ADDENDUM

PROJECT: Jefferson Community Health Center
Patient Wing and Administration Renovation
Fairbury, Nebraska

AD-2

DATE ISSUED: Friday, January 25, 2013

2 Floor Plan
Scale: 1/4" = 1'-0"

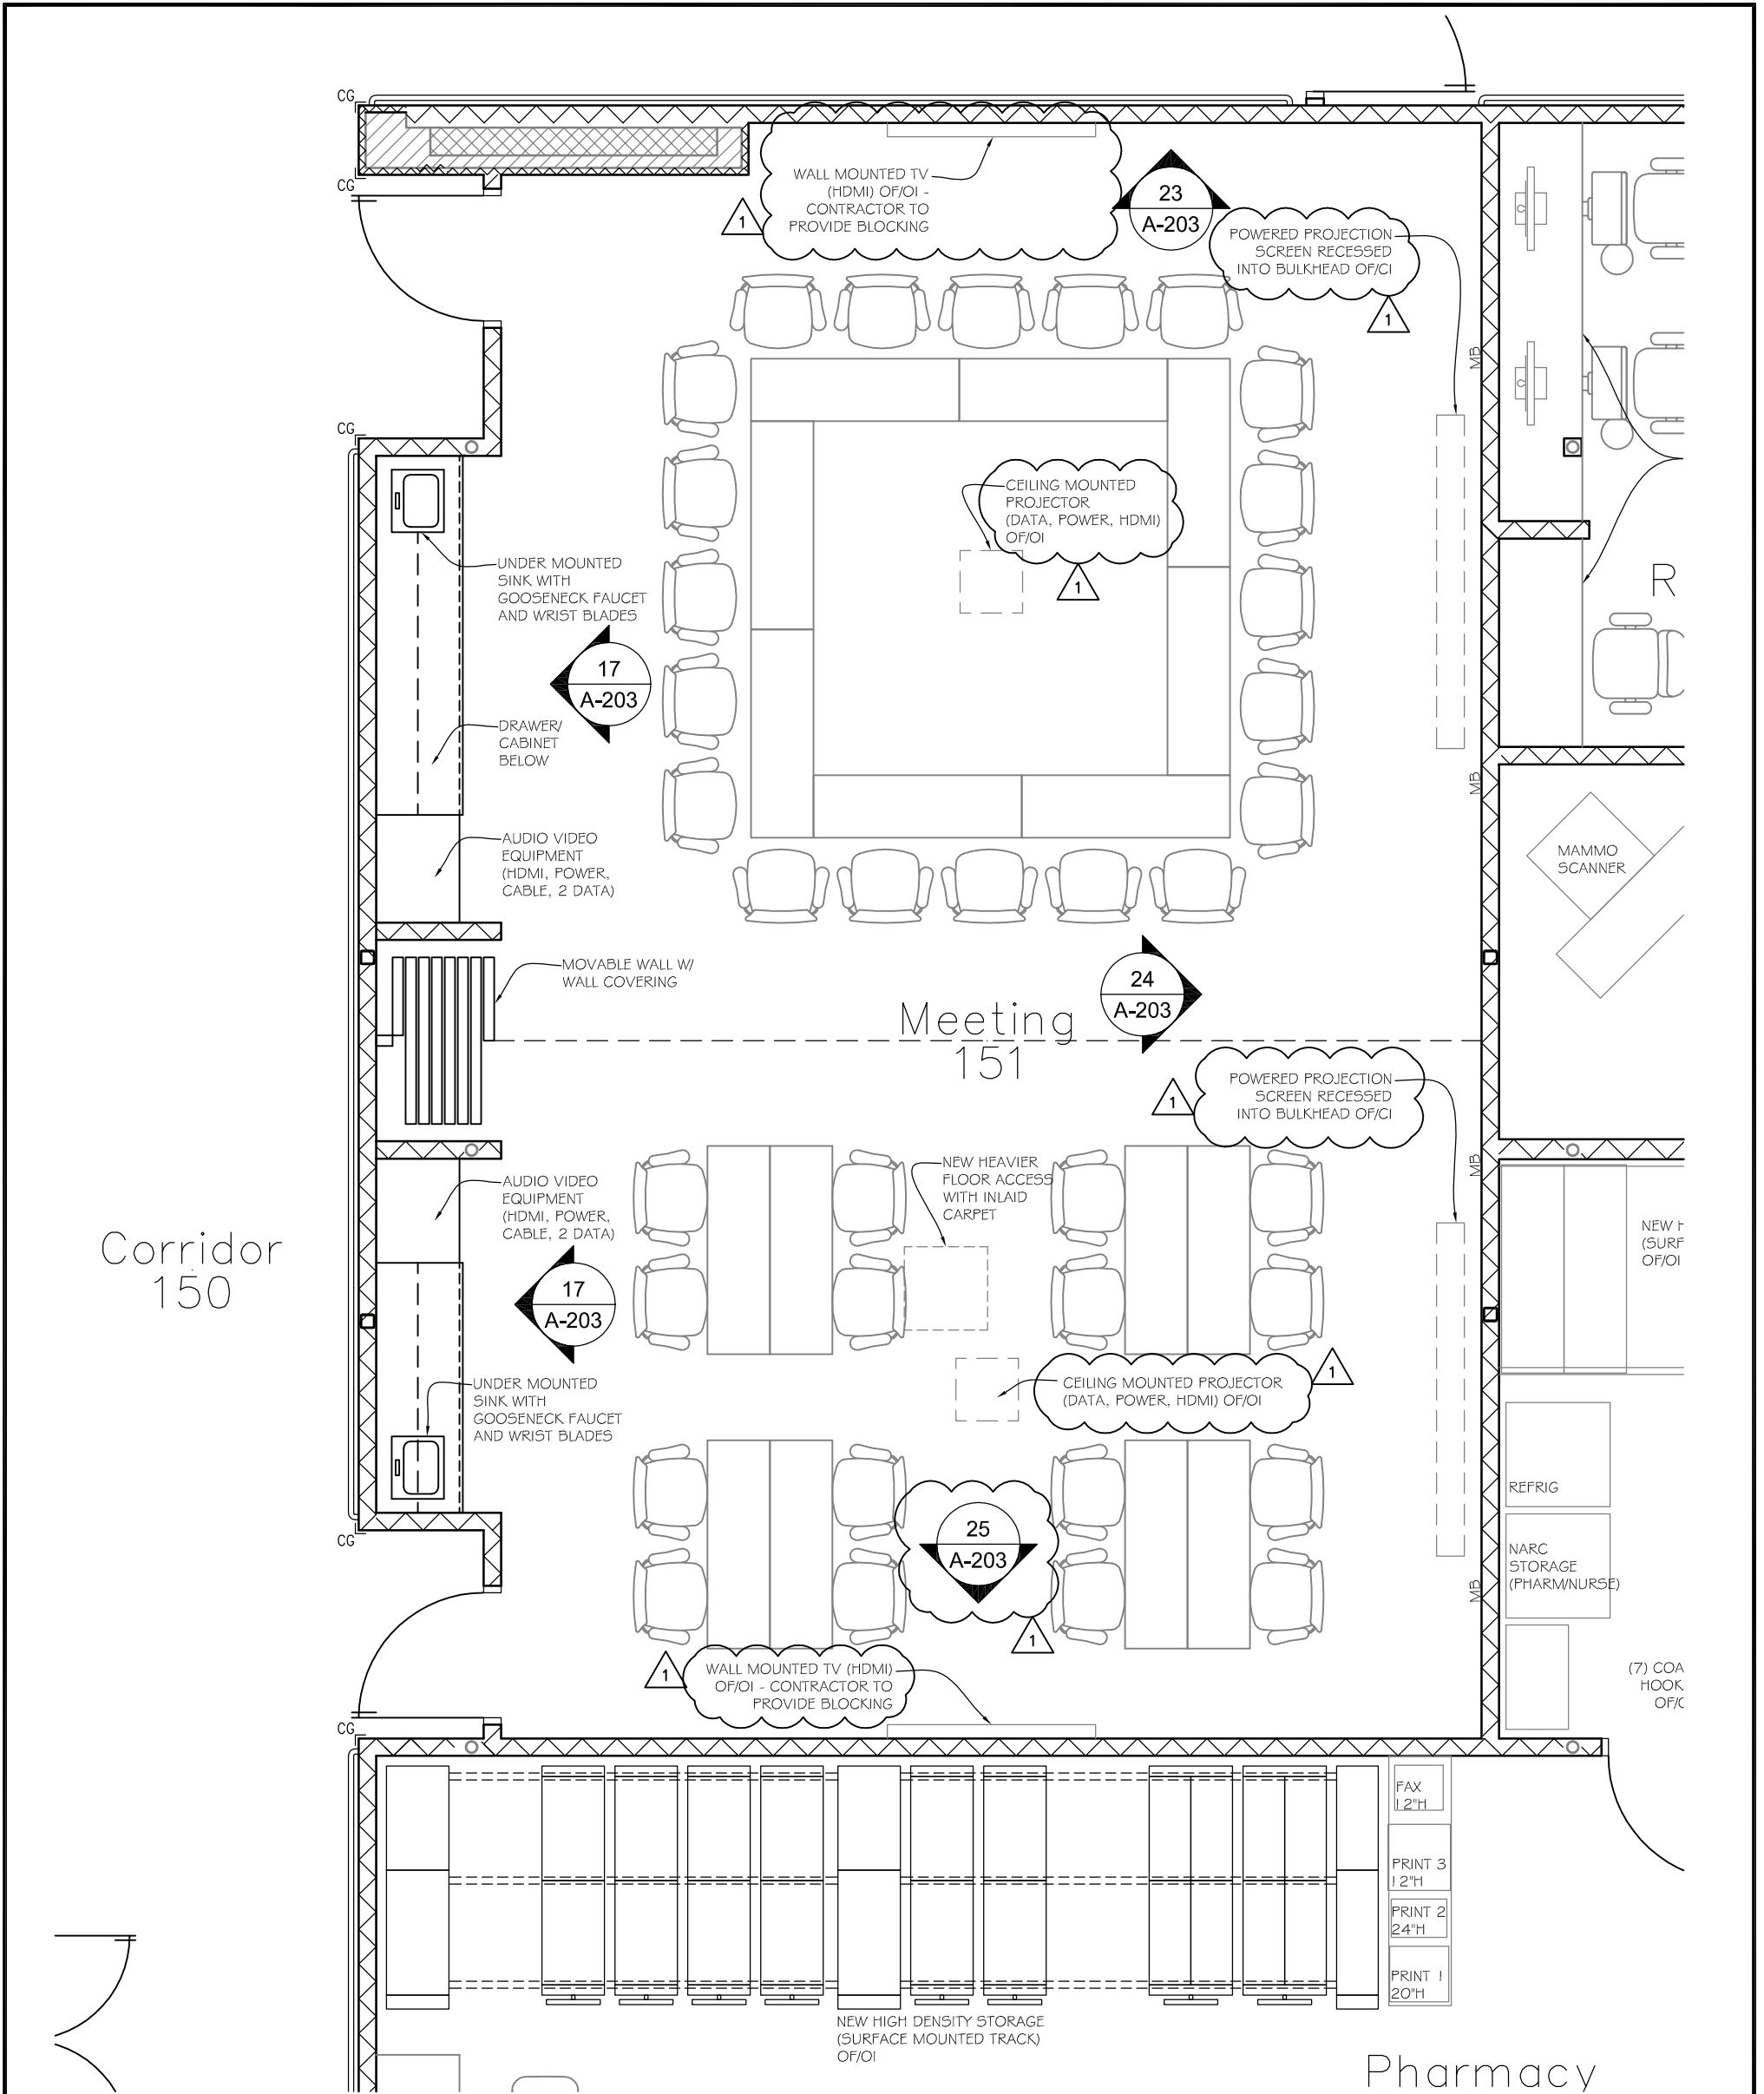
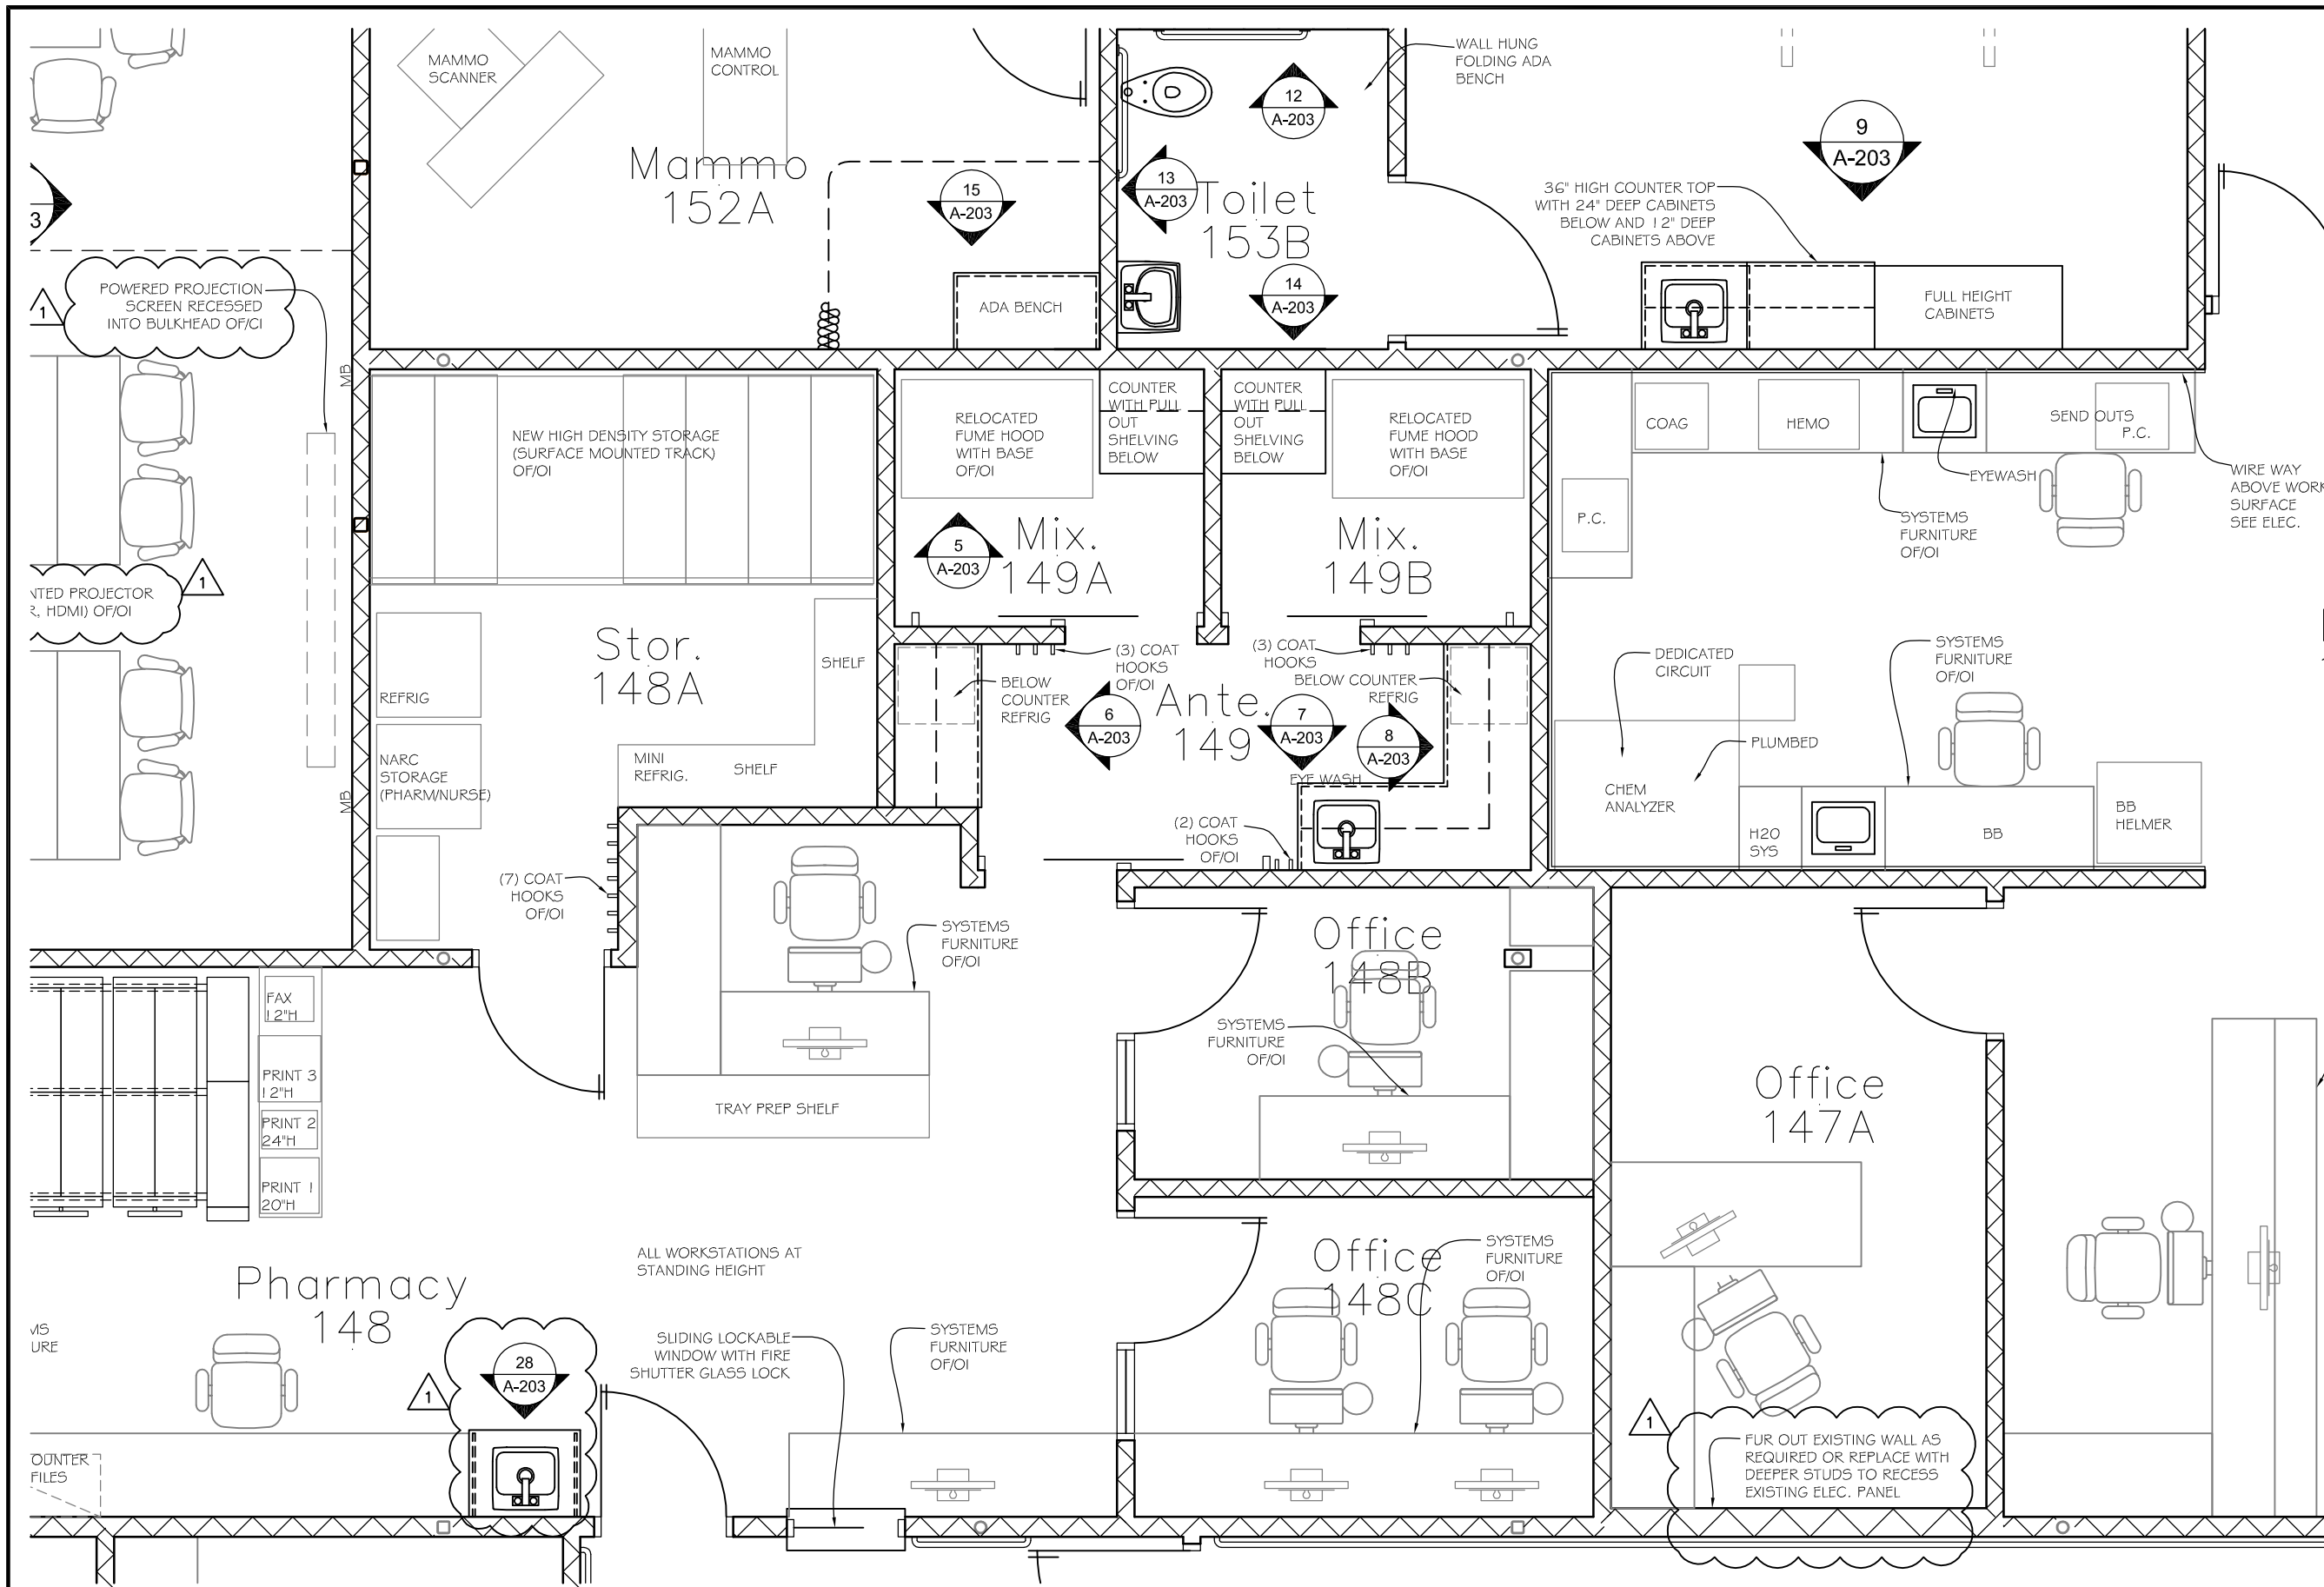
In reference to **Sheet A-401.1**, see attached Sheet A-401.1 and A-401.2 for revised enlarged plans.

1 Floor Plan
Scale: 1/4" = 1'-0"

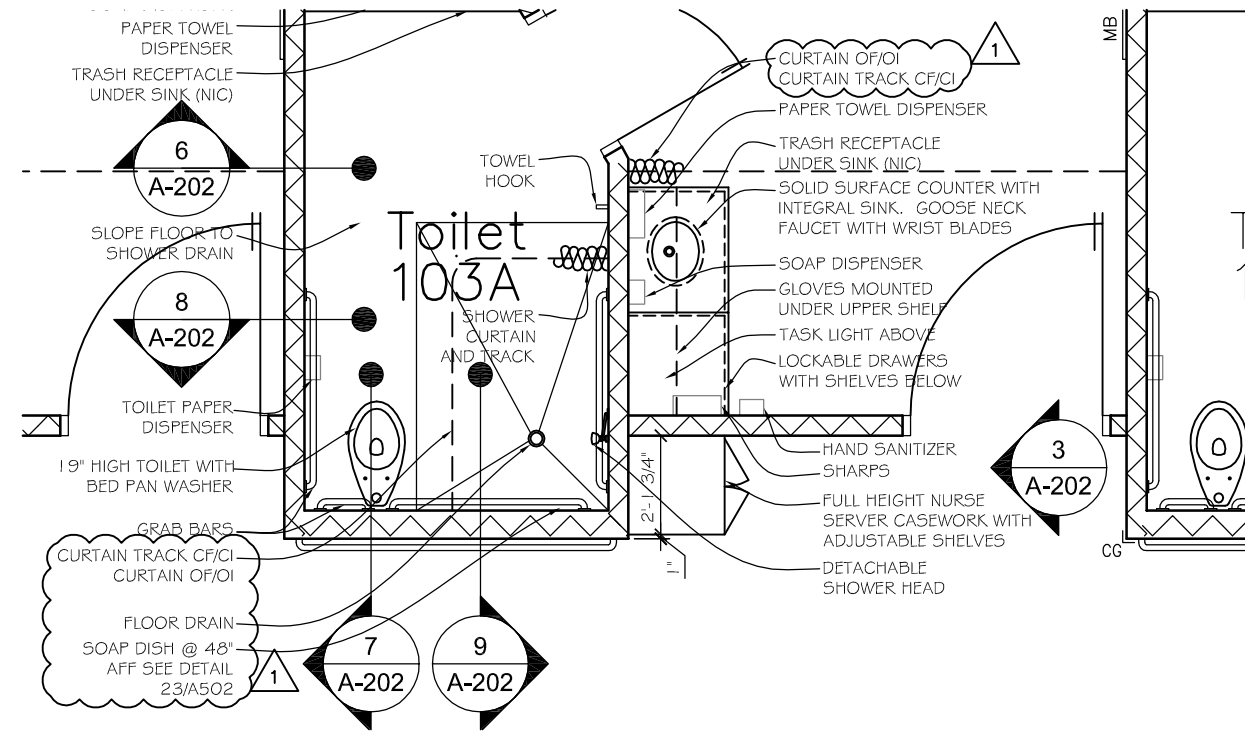
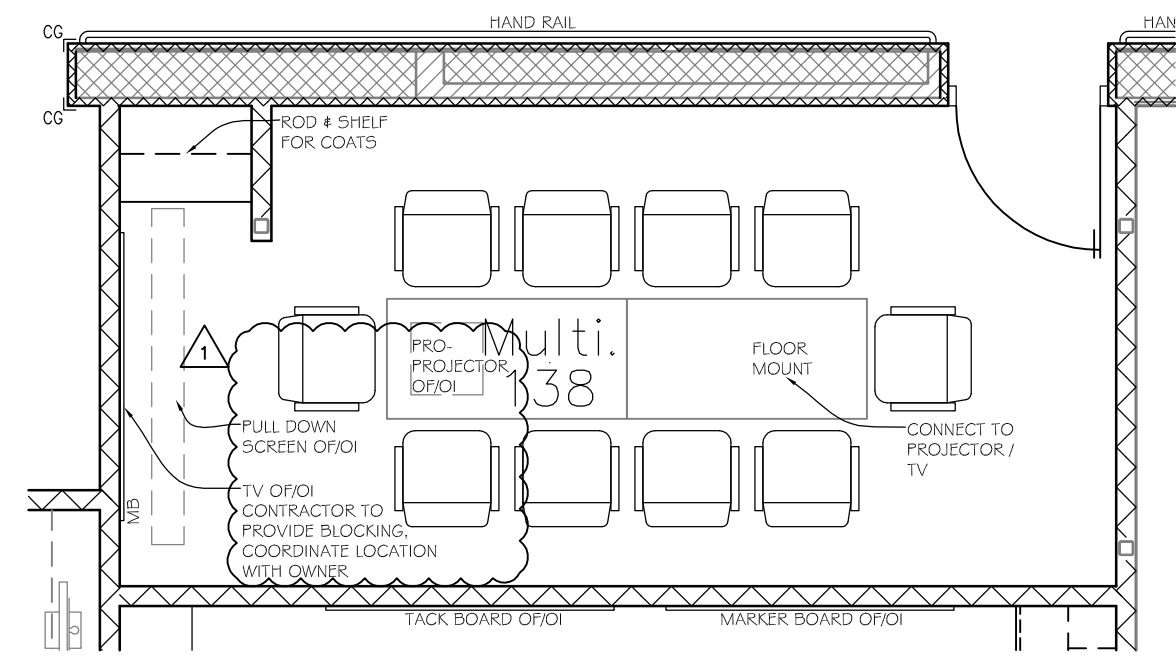
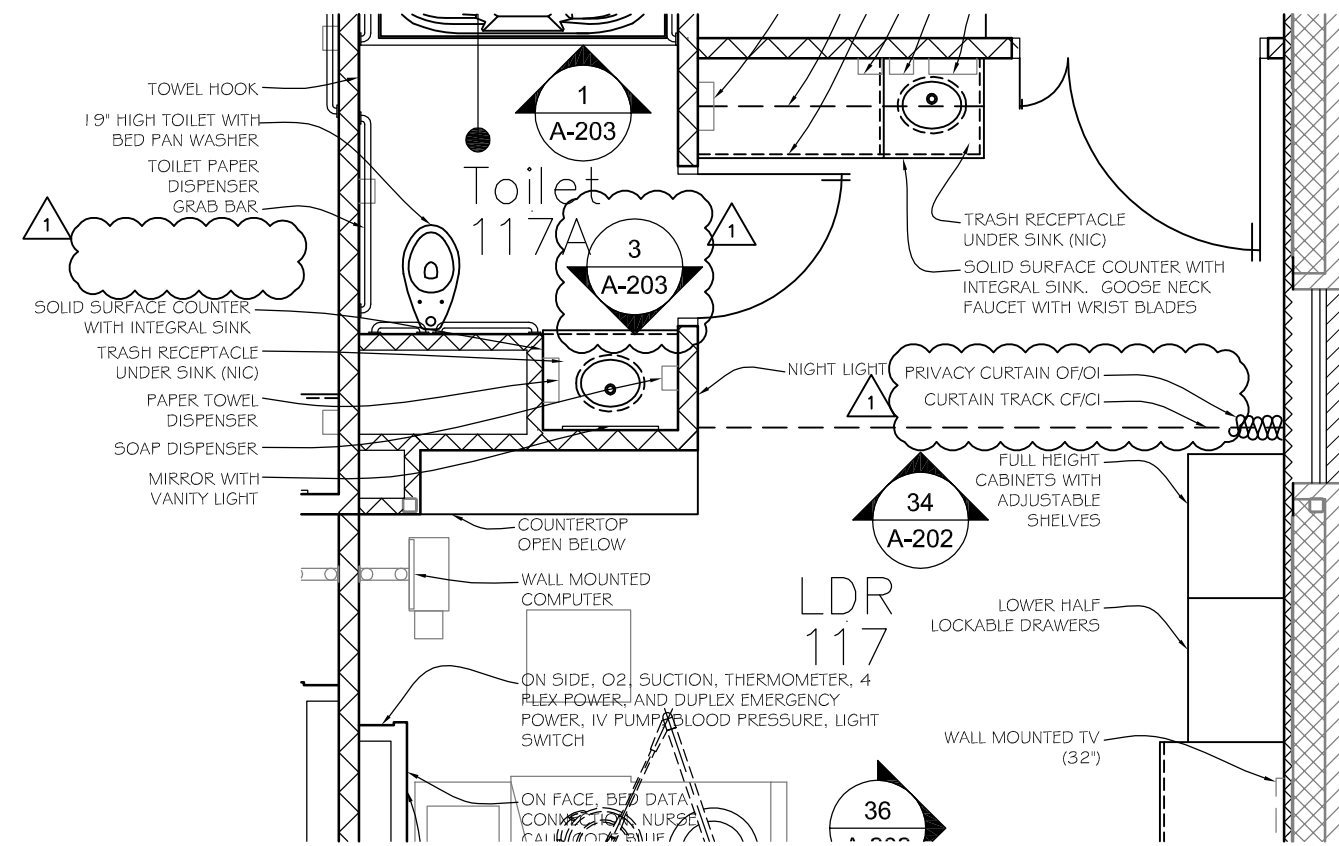
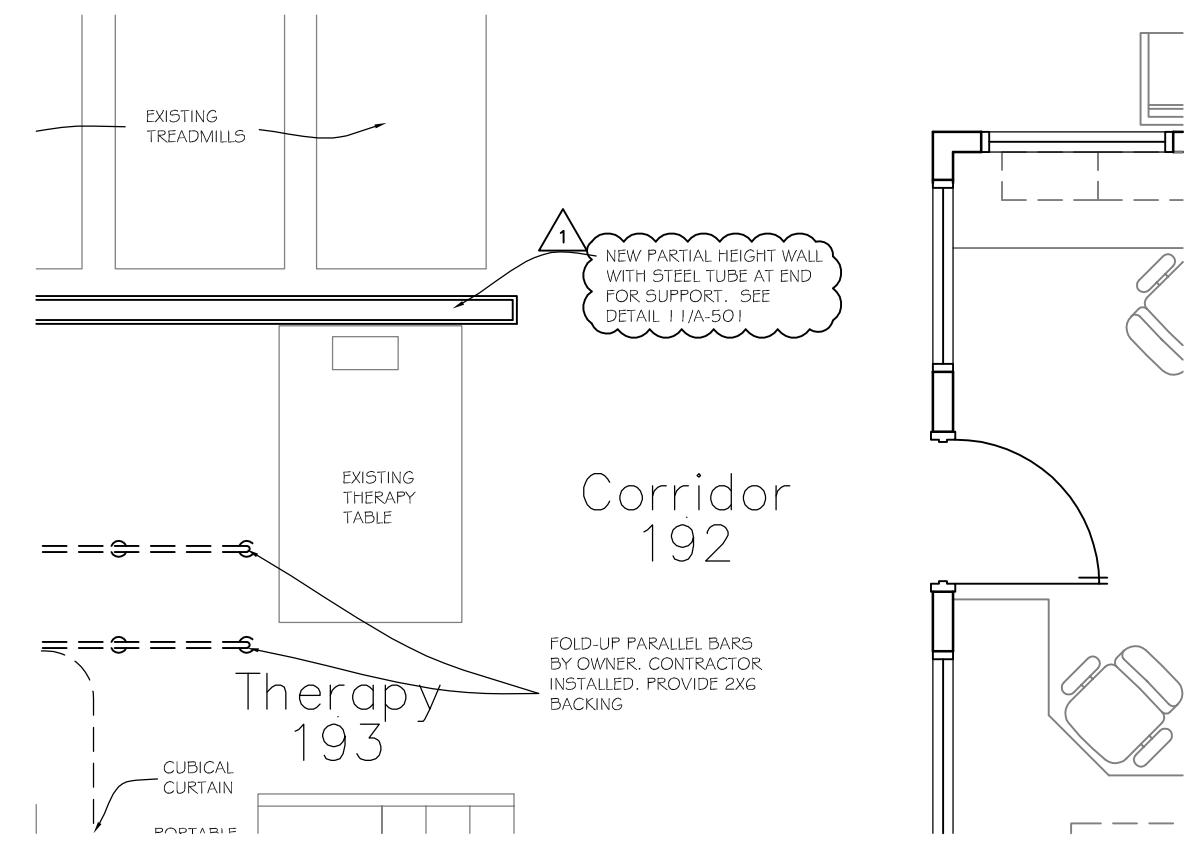
In reference to **Sheet A-402.1**, see attached Sheet A-402.1 for revised plans.
